## OCS Exhibit-1.1S

P.S.C.U. Docket No. 17-057-09

OCS Data Request No. 4.03

OCS 4.03: Reference Exhibit 1.3, Excel file data tab:

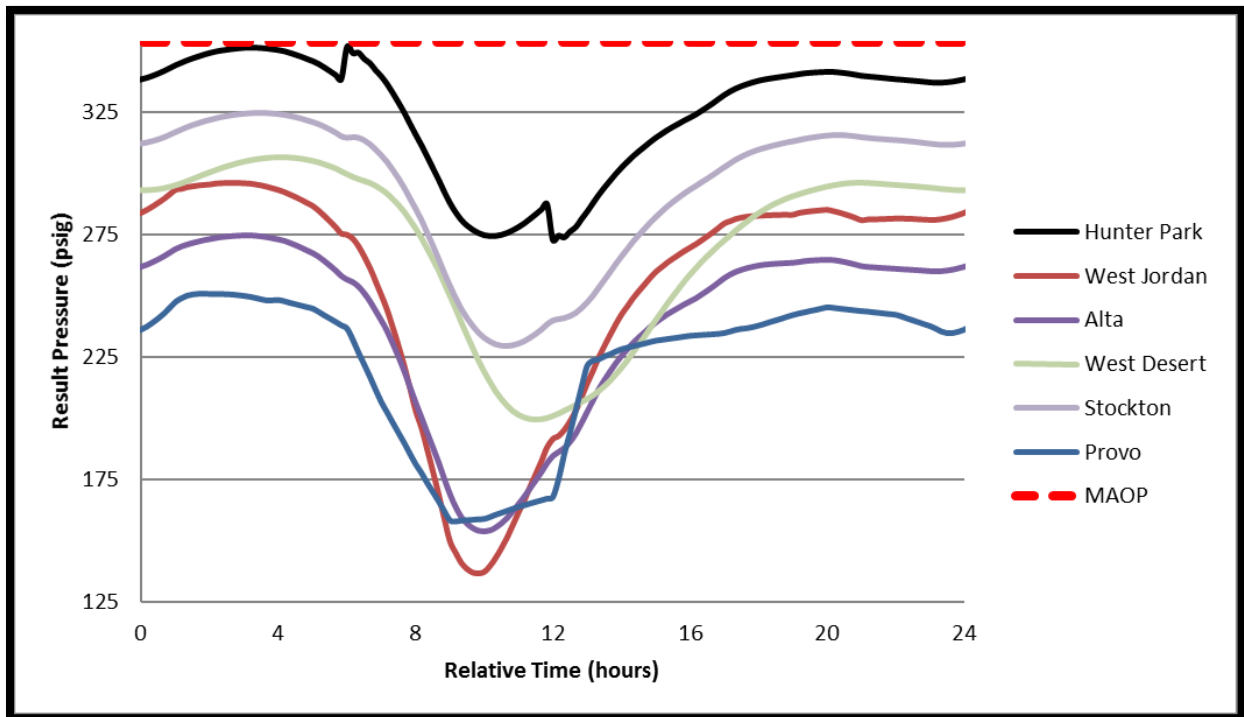
- Please explain why the deliveries (1740) in excess of peak hour demands during hours 0 – 5 cannot be used to pack the DEU system and reduce the need for 310 of peak hour service during hour 8;
- Please explain why total peak hourly demands for the hours 0 – 23 exceed the total peak day deliveries for hours 0 – 23 by 303; and
- Please explain why the Company couldn't begin packing its system prior to hour 0 in anticipation of a peak day.

- The Company already uses system pack to feed peak-hour needs. The figure below shows the pressure at Hunter Park along with some of the key points in the same area of the high-pressure (HP) system. The pressures at Hunter Park reach the maximum allowable operating pressure (MAOP) in the early morning, which indicates the system is as packed as is physically possible. When the system is at the peak-hour, the pressures in West Jordan are near operational minimums.

c. Regardless of when the system begins to be packed, when the pressures reach MAOP, additional volumes can no longer be safely accepted into the system. In the figure provided above, the MAOP is reached at Hunter Park prior to the peak-hour indicating that the system is fully packed.
